WAHROONGA ESTATE

161-163 AND 167-169 FOX VALLEY ROAD , WAHROONGA

Council RFI Response Document - 19.05.2023

This document has been prepared to inform the council of updates of amendments made to the drawings that specifically responds to the queries raised within the Ku-ring-gai Council letter of summary of amendment - amendments and clarifications required.

GENERAL ARRANGEMENT PLAN - GROUND FLOOR
(SECTION 4.56 SCHEME)

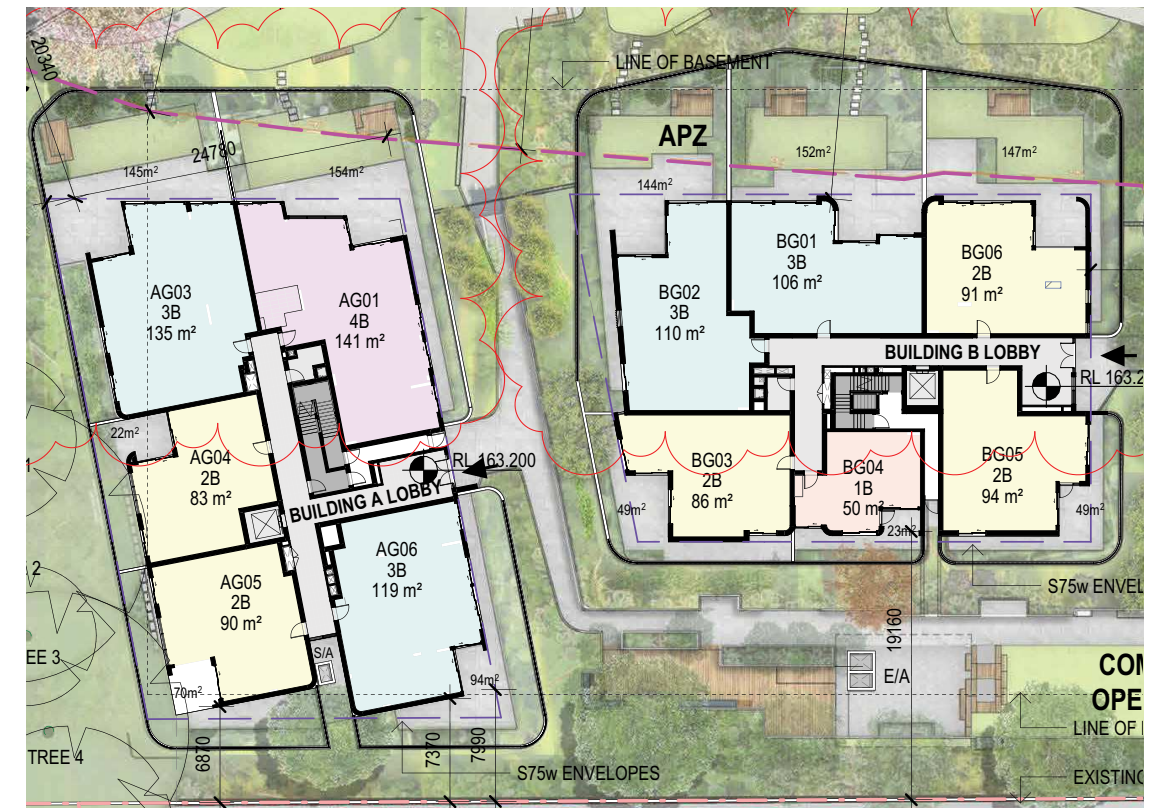
The proposed modification appears to involve changes to a number of the terraces as a consequence of the proposed amalgamation of the units within Buildings A and B. The modifications to the private open space areas of the units should be detailed on the plans and within Section 3.1 of the Statement of Modification.

A schedule should be provided on each of the floor plans that clearly detail the changes to that plan as compared to that which was approved.

1. Changes have been clouded on relevant sheets with a tag that corresponds to the change.
2. A schedule has been added to each sheet, listing all changes per sheet.
3. Changes to private open spaces have been included in the plans - refer to General Arrangement Plans A2003-A2008

VIEW OF BUILDING C
(SECTION 4.56 SCHEME)

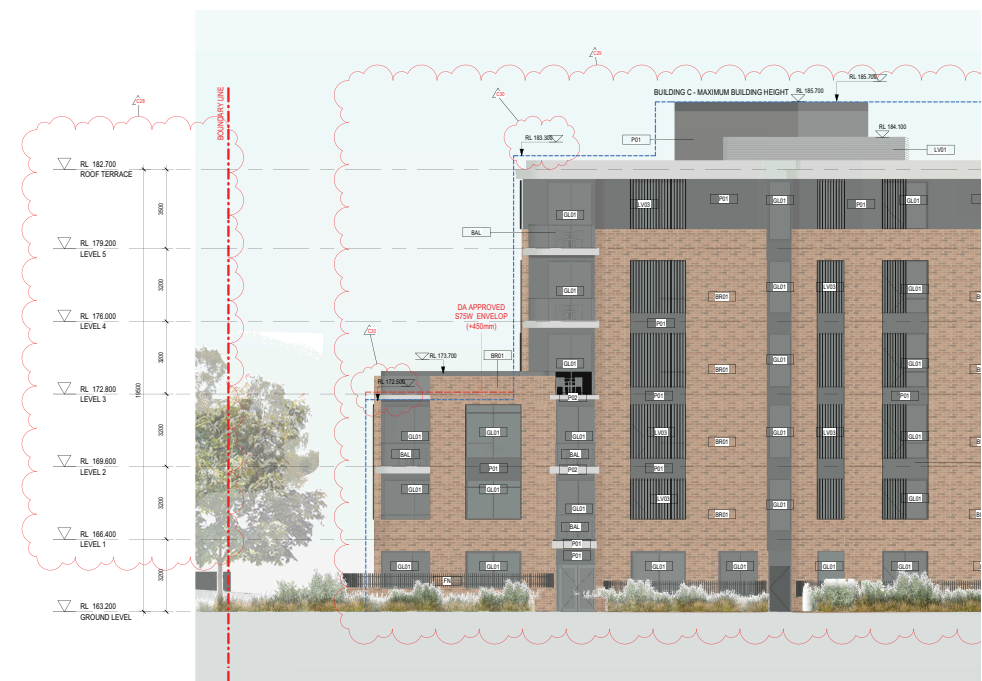
The proposed changes to the façade including materials are unclear. It would be beneficial to provide specific details relating to the changes to the materials and finishes. A schedule providing a comparison between the approved and the proposed would assist in this regard.

The images show the artist's impression of both the DA approved scheme and the Section 4.56 scheme. Evident from the comparison, the original design intent of approved DA scheme has been maintained as well as the material pallet. Although some design elements have been modified for build-ability purposes, they continue to provide a high design quality.

SECTION 4.56 - Building C - East Elevation (Sheet A 3021)

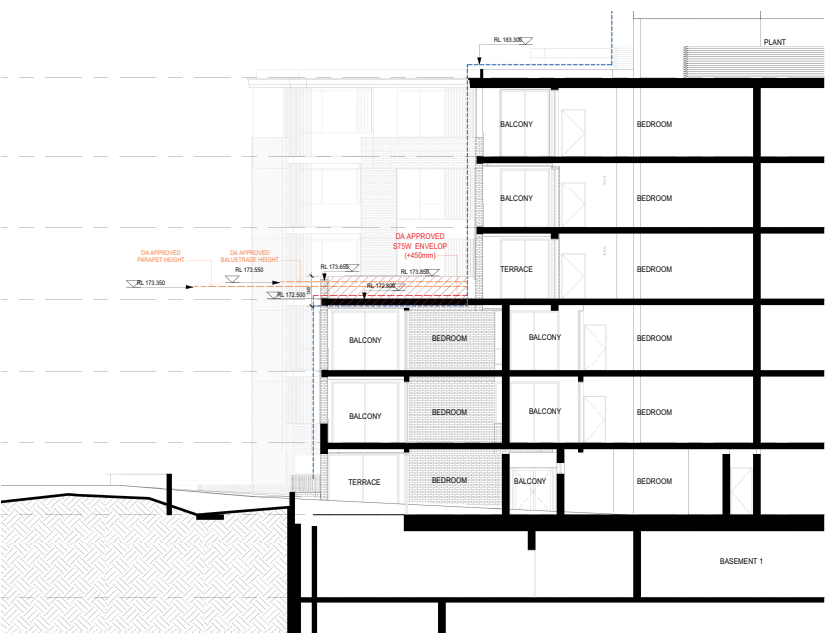
Council’s calculation of the variation sought is 1.15m on the western elevation and 1.2m on the eastern elevation – Building C. This is based off a variation to the maximum RLs indicated on Drawing A007, Section 75W – Urban Form Control Diagrams – Roof Plan Issue G dated 24/07/2020 forming Condition A8(1)(j) of Concept Plan MP07_0166 (as modified). The breach appears to extend to the balustrade and brick wall/s.

(a). It would be of great assistance if the approved heights of the balustrades including RL’s could be indicated on the eastern and western elevations of Building C so that it is clear as to the proposed additional height and the elements that contribute to that additional height.

(b) The applicant’s request to vary the building height to this portion of building has not identified adequate planning grounds to justify the variation. This will need to be further justified and reflect the actual breach sought to this portion of the building.

(c) Maybe an additional section through Building C, in addition to Drawing No. A3103, Issue F, that clearly indicates the additional height. The additional height variation appears to relate to both the brick parapet and the glazed balustrade that is setback from the edge of the building, however it is difficult to determine based on the information submitted as part of the application.

The envelope has been updated to reflect approved section 75W Envelope - Refer to all Elevations and Sections.

a. The approved heights of the balustrades, including RLs have been indicated on the Eastern and Western Elevations of Building C - refer to submitted drawings A3021-ELEVATION - BUILDING C_Rev H and A3023-ELEVATION - BUILDING C WEST_RevG

b. The Sections and elevations have been updated to reflect the proposed breach. Refer to item 4(a) on page 8 for further justification.

c. An additional section through building C has been provided reflecting the additional height - Refer to A3106 - SECTION 02 - BUILDING C_RevA

An additional height of 300mm above the approved DA scheme height is being sought.

TYPICAL BALCONY DETAIL
with flush floor transition above set down, showing increased slab thickness 230mm along balcony and 300mm along the back span.

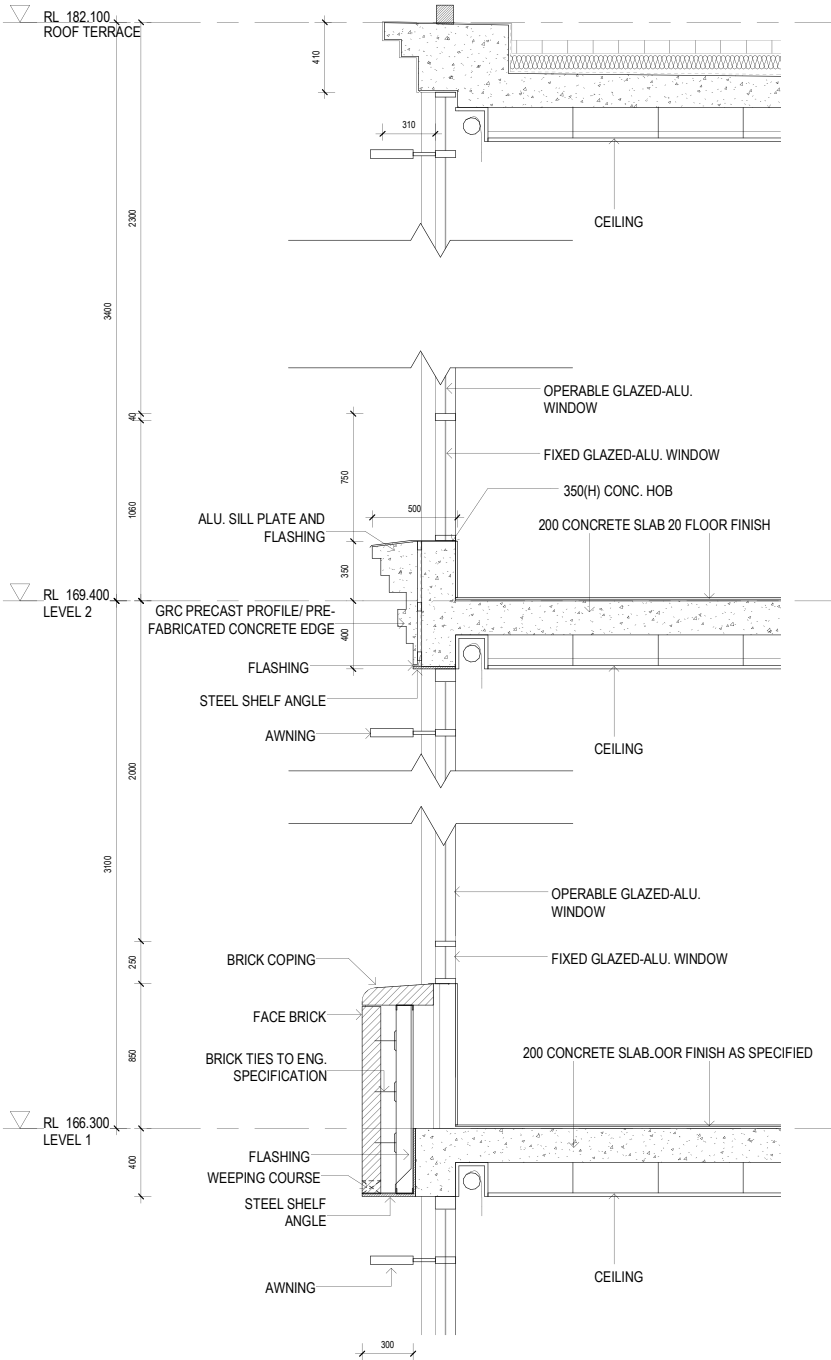
The applicant's explanation for the increased floor to floor height is: "The proposed increase in floor to floor heights arise as a result of the detailed design requiring additional ceiling area to provide the required servicing.

It is noted that the approved floor to ceiling heights do not change". The Section detail – Typical northern façade on Drawing A3202 Issue F nominates a slab thickness of 250mm, in lieu of the approved thickness of 200mm and an additional 50mm from the fixed aluminium window to the floor level above. Further clarification is sought to the reasoning of the floor to floor increase to each level, given the details provided do not clearly identify any services between each floor. This clarification is required to ensure that the development, as modified will not breach the building height to Building A, B and C given the proposed modifications seeks a proposed at RL185.70 (to the lift overruns), which is the maximum height limit established under the Concept Approval.

To meet compliance with new NCC 2022 and AS4654.2 / AS 3740, structural falls are required to be provided in the wet areas and balconies which achieves min 1:80 falls as opposed to 1:100 min in the previous NCC 2019. This requires the structural slab thickness to be increased by approx. 30mm nominally, conservatively rounded to 50mm. Furthermore, the proposed development seeks to achieve flush floor finish by eliminating hobs in bathrooms and balconies, thereby improving accessibility for the occupants within the apartments. This solution requires slab set downs and along with the required ceiling zone for services like mechanical ducting, drainage system, fire sprinklers and electrical services, an additional 50mm-100mm per floor plate is needed for both compliance and buildability to ensure 2700mm clear bulkhead-free clearance can be achieved to adhere to ADG requirements.

SECTION - BUILDING A (A 3101)
(SECTION 4.56 SCHEME)

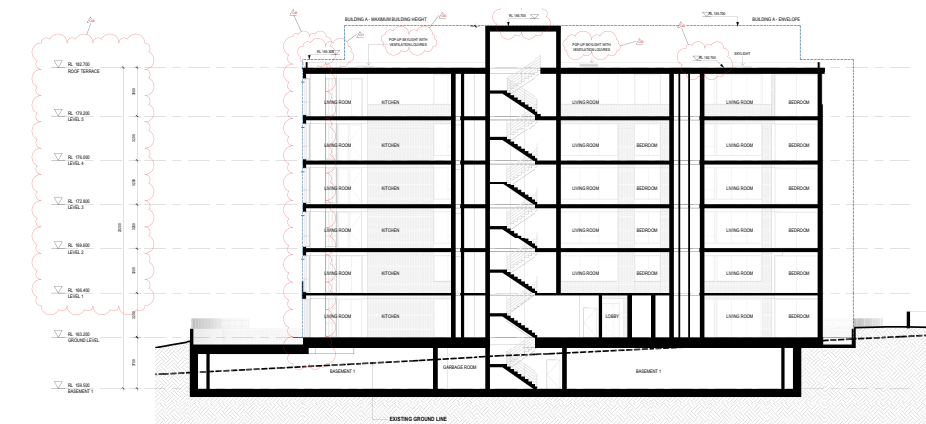
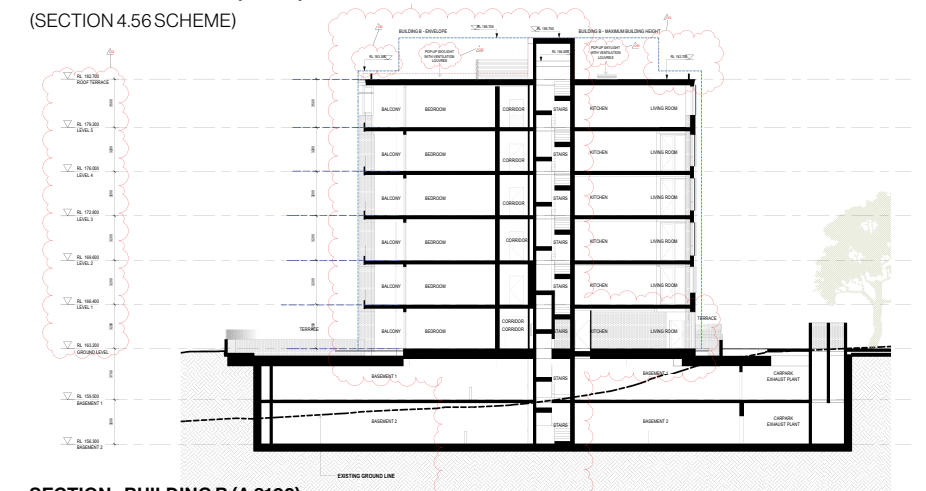
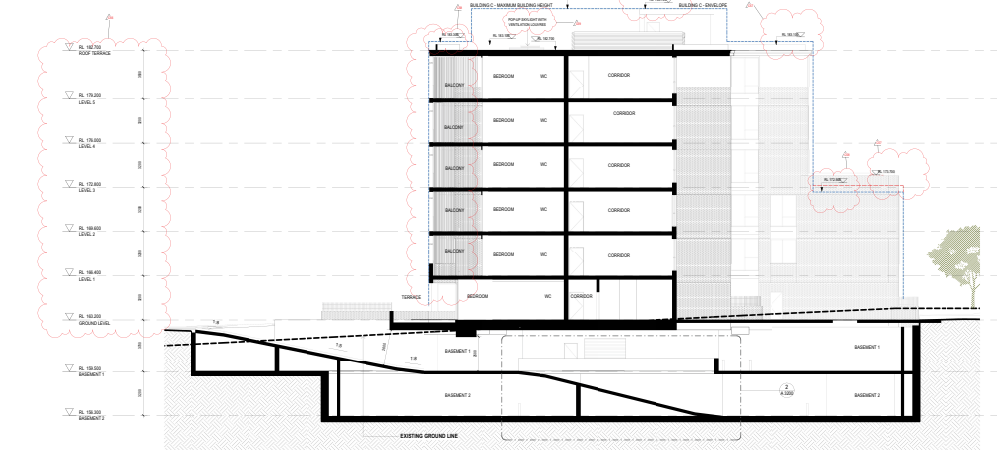
NOTE 2: The architectural documents contain inconsistencies requiring clarification in light of the above comments. Section drawings indicate an upturn is retained in some instances – albeit now unmodulated – but not in others. Example - Dwg A3101 (F) for BLG A compared with dwg A3102 (F) for BLG B and dwg A3104 (F) for BLG E.

The sections provided in the Section 4.56 submission are as per the DA approved pack. Sections have been taken through various areas of the facade in Buildings A, B & C as per the images alongside to show the various facade treatments.

OVERALL NORTH ELEVATION
(SECTION 4.56 SCHEME)

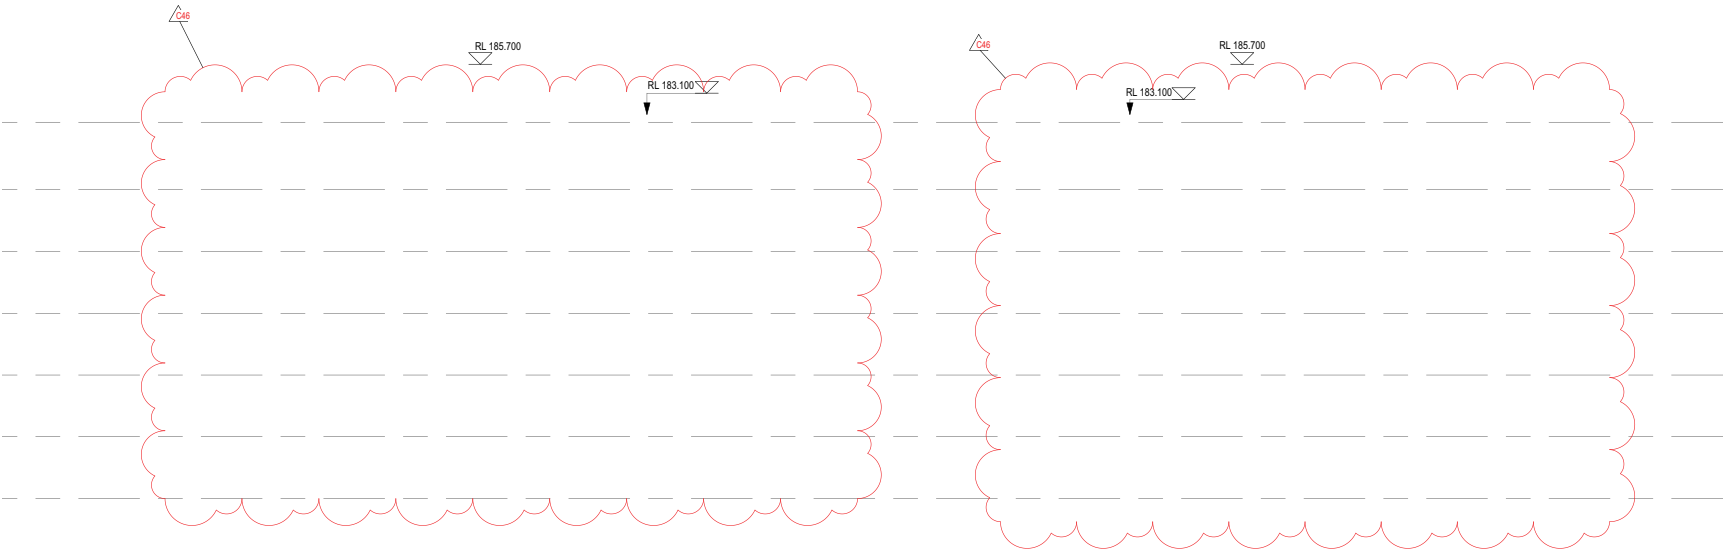
Balcony balustrading - The ADG does not support full-height balcony glazing. The addition of operable screening panels and/ or solid upturns to a height that still allows excellent outlook from a seated height (400-600mm) with upper portion glazed, or partially solid with full-height components of glazing will be required.

The design has appropriately located balconies to maximise available views and sunlight, whilst also being conceived as an extension of living spaces, to enhance the liveability for the occupants.

Further to this, the design has integrated the balconies to ensure they contribute to the overall architectural form and detail of the building. The building presents a number of balcony treatment and conditions, relating to orientation, view opportunities, elevation, privacy, and architectural composition. As a result, there is not one solution for the proposed balcony / balustrade detail within the development.

Acknowledging the specific comment relating to full height glazing, this is not common across the entire project. This has generally only been applied to upper levels, noting ground floor has perimeter fencing and level one has a solid spandrel, where privacy from the public domain is no longer of concern. It’s noted that in a dense urban area, this particular note to glazed balconies would be more applicable.

SECTION DETAIL THROUGH SKYLIGHT
(DA APPROVED SCHEME)

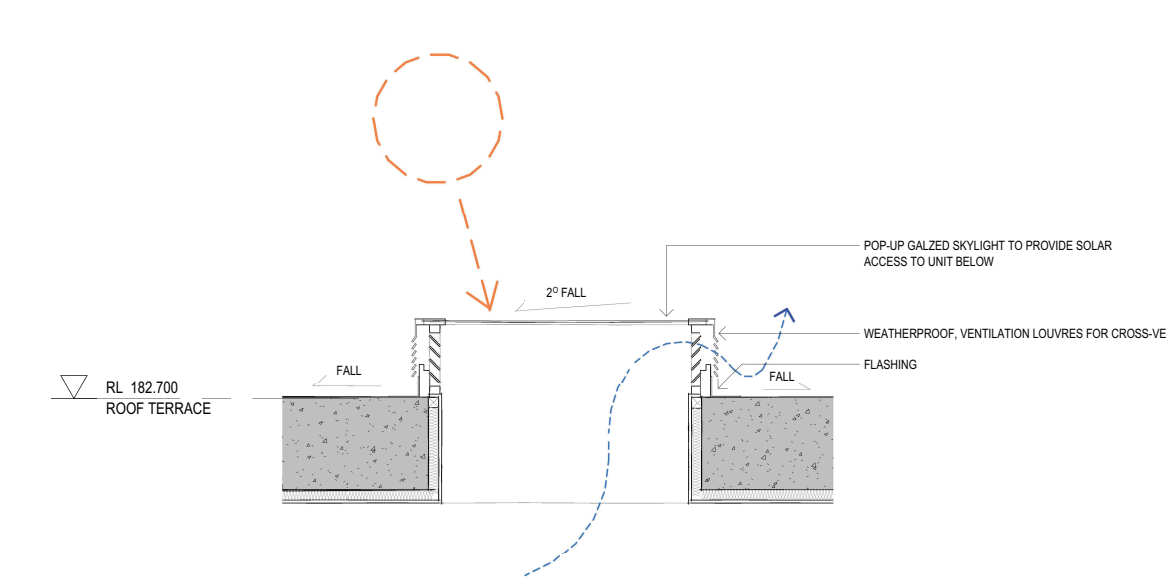
Roof design – Confirm that ‘skylights’ are pop-up roofs with vertical windows as clerestory types.

Skylights have been incorrectly labelled on the drawings and are per the details shown. The skylights provide solar access through the glazing above and ventilation through the surrounding, weatherproof, louvres.

Where skylights are required for both solar and cross-ventilation purposes, a hybrid pop-up skylight with clerestory, ventilation panel configuration has been proposed.

No chnages to the DA approved design has been proposed.

BUILDING E - BASEMENT 1
(DA APPROVED SCHEME - NO CHANGES PROPOSED)

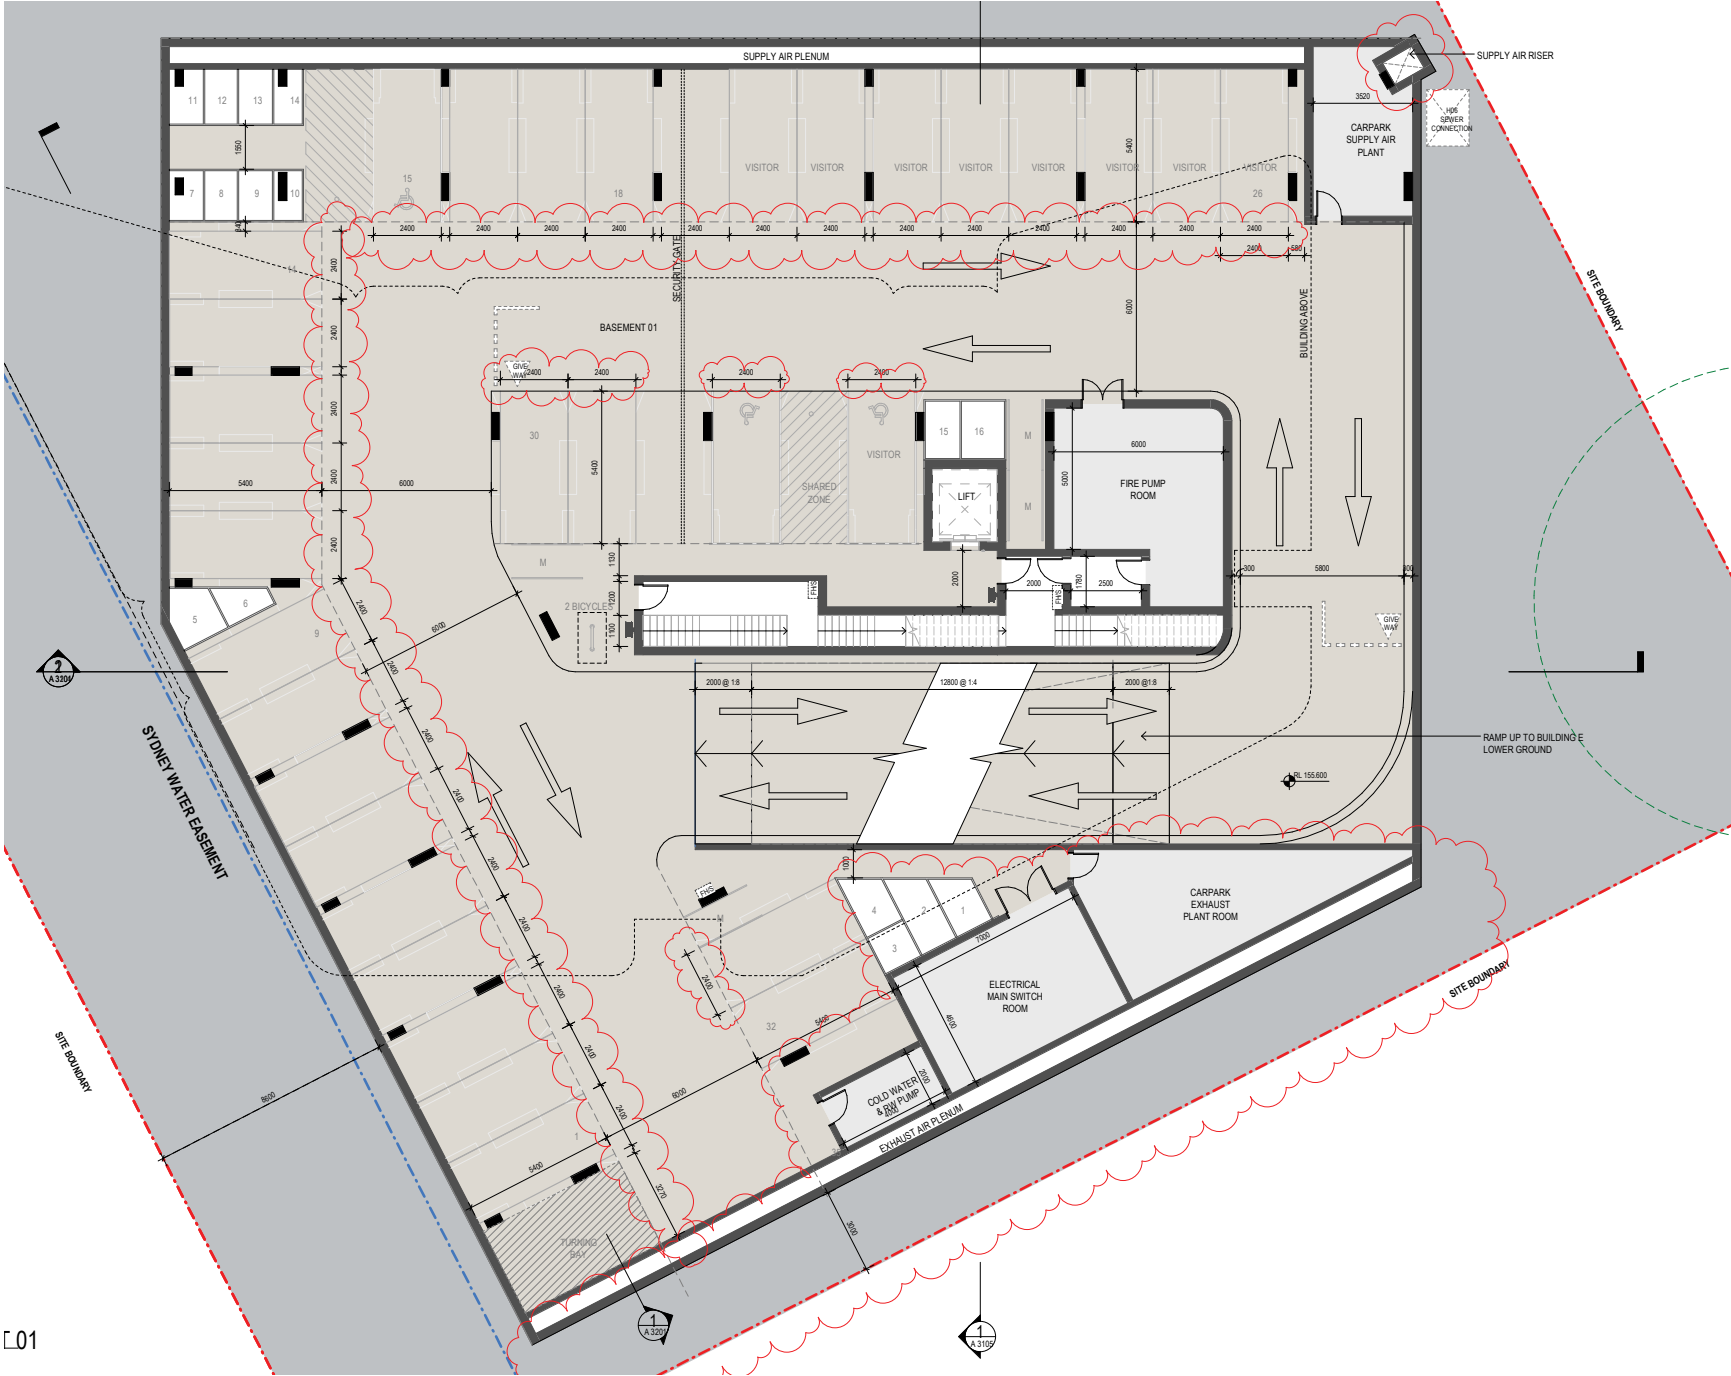
At least one visitor car space is to be accessible and be provided within the basement for every 6 apartments or part thereof and is to comply with the dimensional and locational requirements of AS2890.6:2009

One accessible visitors space is provided in the Building E basement 1. Note that this is as per the approved DA scheme and has not changed.
